Staff Report

Historic Review for Use of Substitute Materials

Siding and Windows

HI-05-20

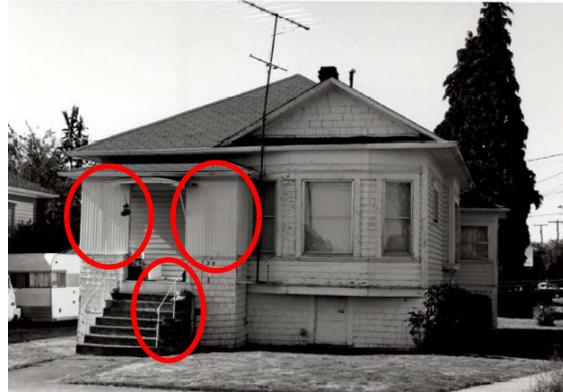
- 1.4 Existing Window Trim Condition. The applicant has indicated that the existing trim around the exterior of the windows was rotted and not salvageable (Attachment D.3). On some portions of the house where trim has been removed, there appear to be some signs of water damage. All the original window trim has been removed.

- Condition 2 Window Trim.** New window trim shall match the size, style, appearance, and materials of the original trim.
- Condition 3 Consistency with Plans.** The proposed requests for the use of substitute materials shall be installed and constructed as described and depicted in the application materials, this report, and in the above stated conditions except as modified by approved revisions and conditions of approval.
